V2500 Propulsion System — Nacelle

SERVICE BULLETIN

**NACELLE - EXHAUST - THRUST REVERER - PIN, QUICK RELEASE -
HOLD OPEN, PRESSURE RELIEF DOOR - RELOCATION OF**

V2500-NAC-78-0124

QUICK RELEASE PIN RELOCATION
FIGURE 1

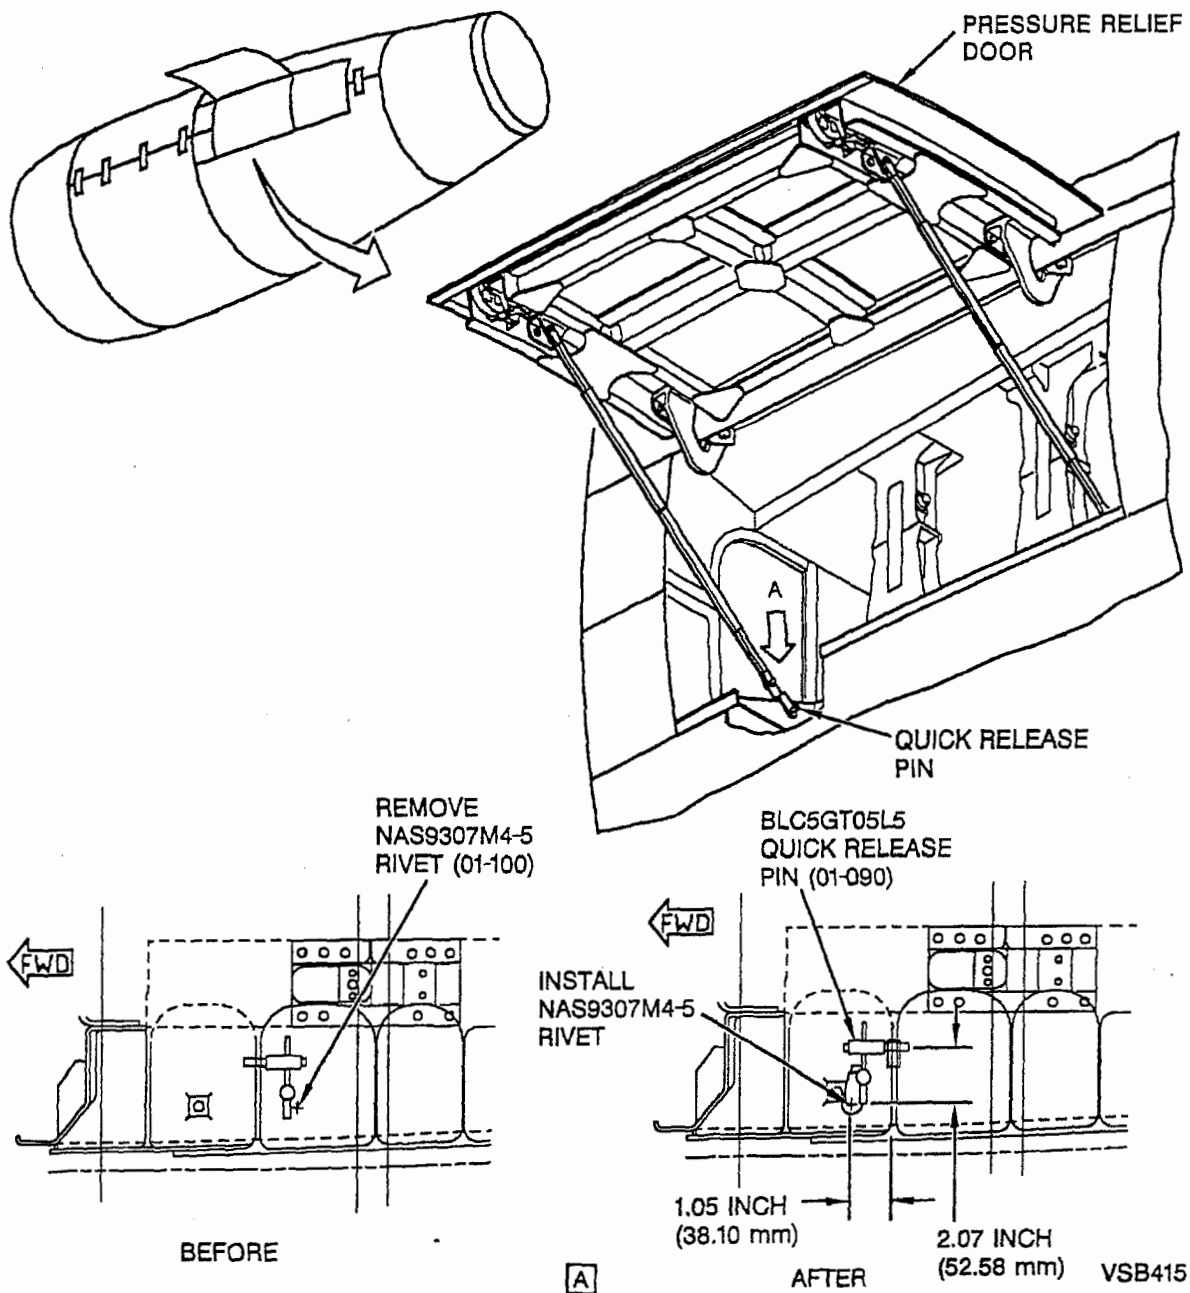
The forward quick release pin used to hold the lanyard on the pressure relief door can be installed in the wrong hole which can cause the pressure relief door to inadvertently open.

The rivet that attaches the forward quick release pin lanyard to the track assembly will be drilled out, the rivet hole in the track assembly filled with a rivet, and the rivet hole in the heat shield covered with sealant. The quick release pin will be relocated and a hole drilled in the track assembly for attachment of the quick release pin lanyard. The lanyard will then be attached to the track assembly at the new location with a rivet.

- (1) Use a 0.128-0.134 inch (3.251-3.404 mm) diameter drill to remove the NAS9307M-4-5 rivet that attaches the forward BLC5GT05L5 quick release pin lanyard to the track assembly. Remove the quick release pin. Refer to Figure 1.

- (9) Use a 0.128-0.134 inch (3.251 3.404 mm) diameter drill to drill a hole in the track assembly for the NAS9307M-4-5 rivet as shown in Figure 1.
- (10) Attach the quick release pin lanyard to the track assembly with a NAS9307M-4-5 rivet (CR3523P-4-5 or CR3523-4-5 rivets may be substituted for the NAS9307M-4-5 rivet).
